AMENDMENTS TO THE DRAWINGS:

REMARKS

Objection to the Drawings

FIG. 2

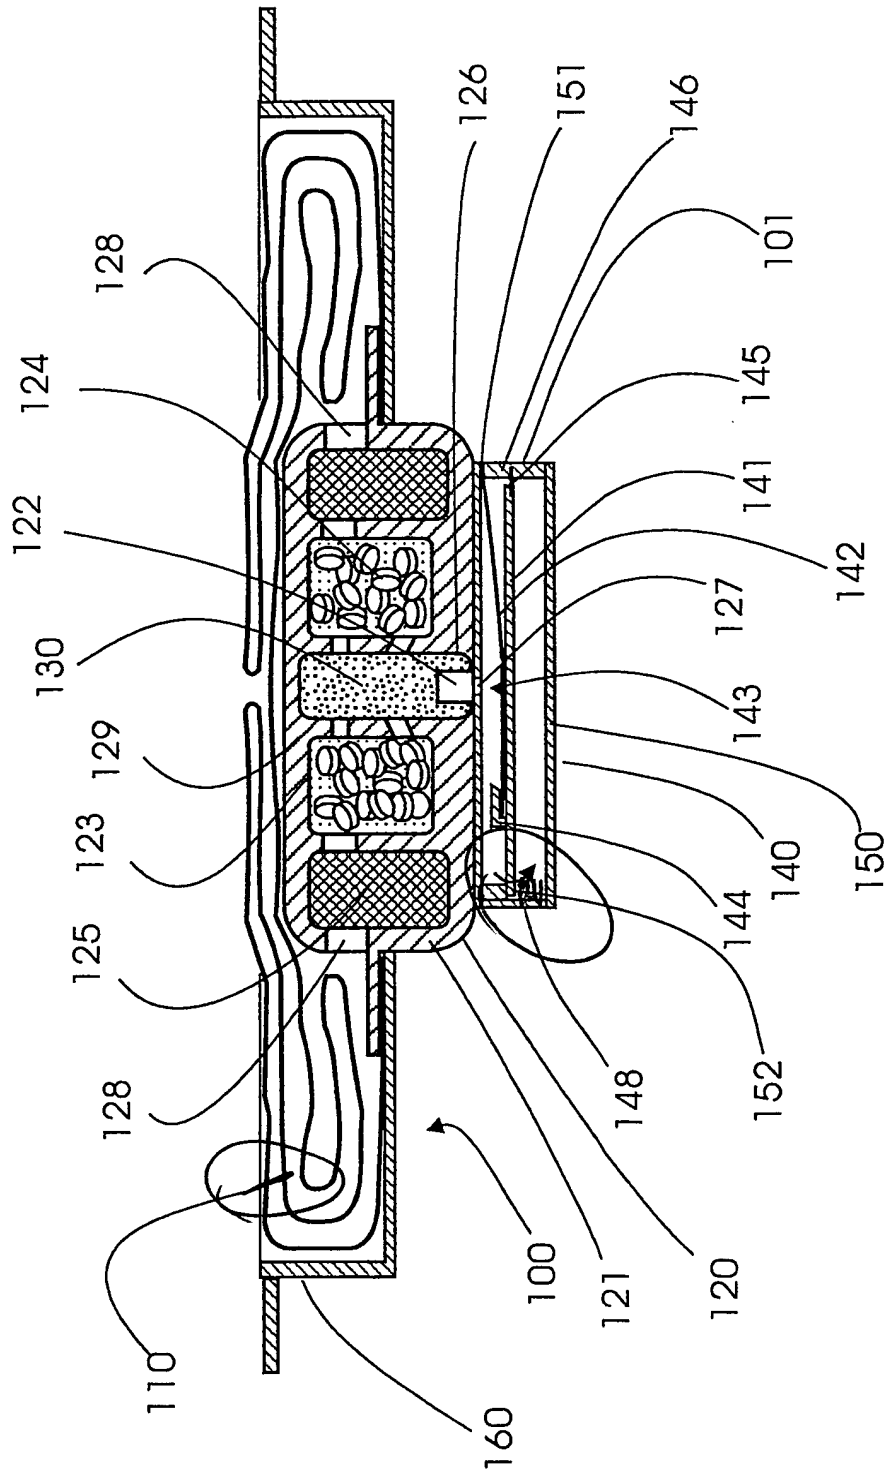
In Fig. 2, the lead line for reference numeral 110 now touches the airbag and the lead line for reference numeral 152 now points to a clearance between the walls 146, 148 and the sensing mass 141.

Fig. 10

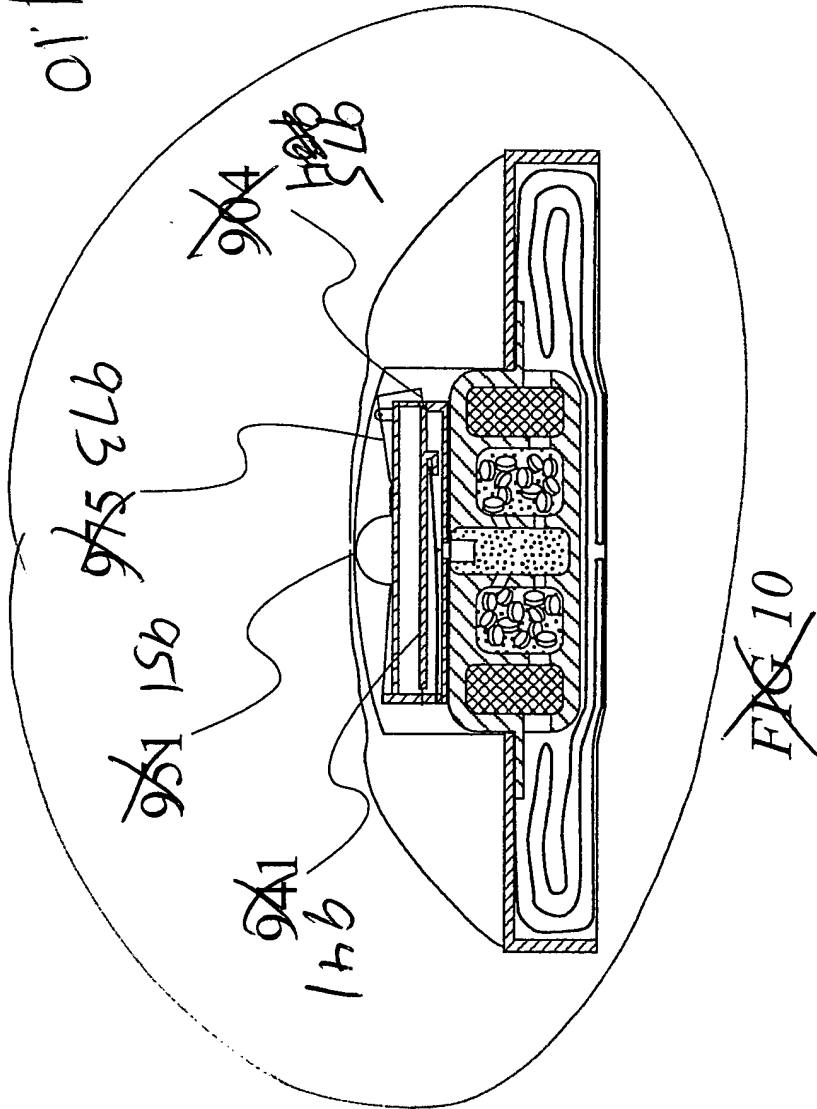
In Fig. 10, the reference numeral for the lead line pointing to the lever is now 973 and the reference numeral for the lead line pointing to the end of the lever is now 975. Also, Fig. 10 is inverted to be in the correct orientation relative to Fig. 9.

Fig. 10A

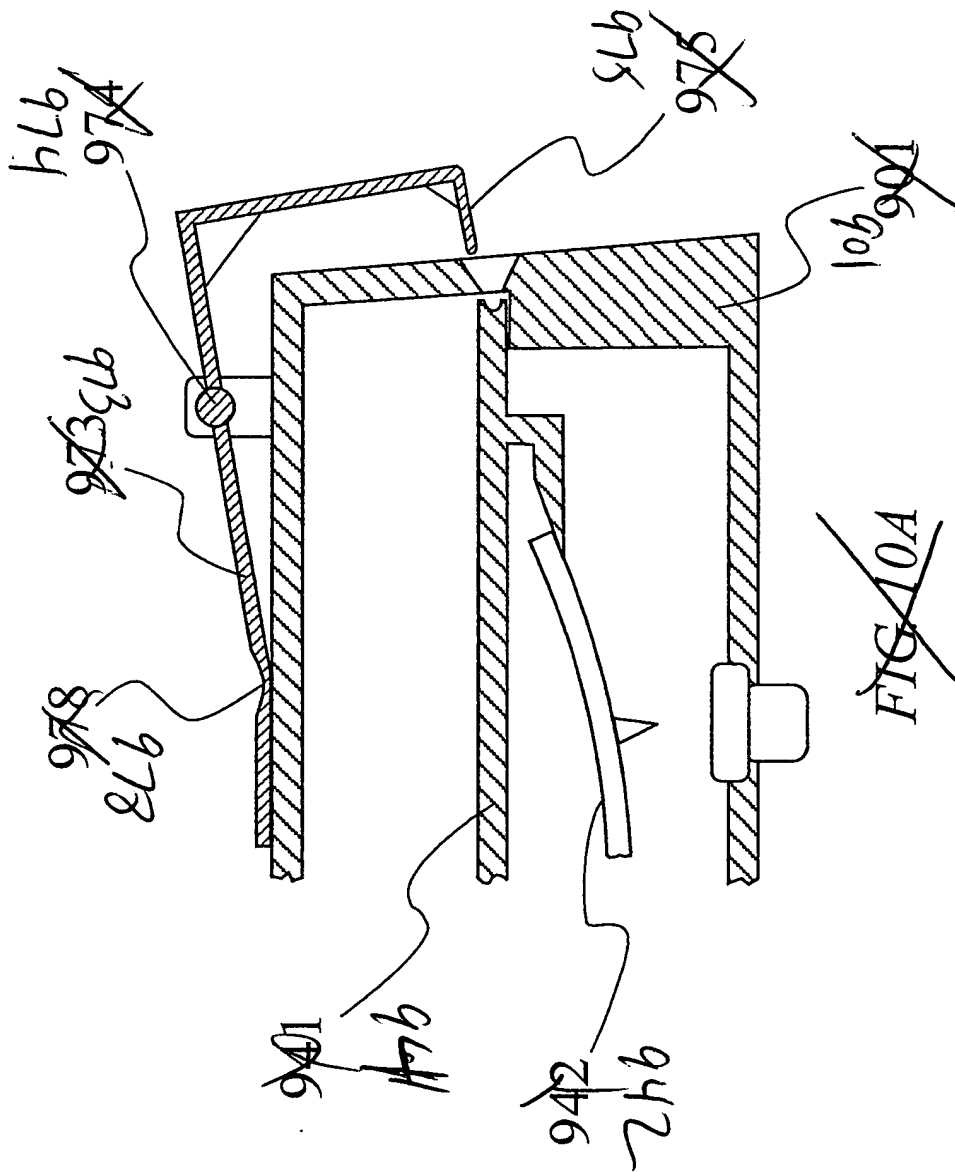
Fig. 10A is inverted to be in the correct orientation relative to Fig. 9.

FIG. 13

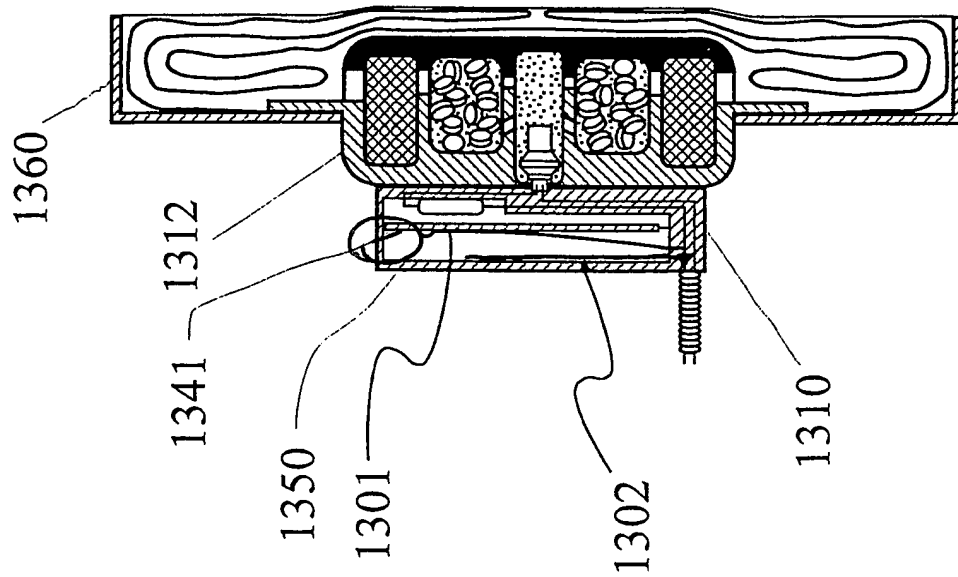
In Fig. 13, the contact 1302 is now better shown on the inside of the top cover 1350 of the sensor housing 1310 along with a clearer separation between contacts 1301 and 1302. Also, the lead line for reference numeral 1341 now points to the sensing mass.

With respect to the embodiment shown in Fig. 13, it is respectfully submitted that it was inherent if not readily ascertainable that the contact 1302 was on the inside of the top cover 1350 of the sensor housing 1310, which is the only position in which it could be contacted by the movable contact 1301.
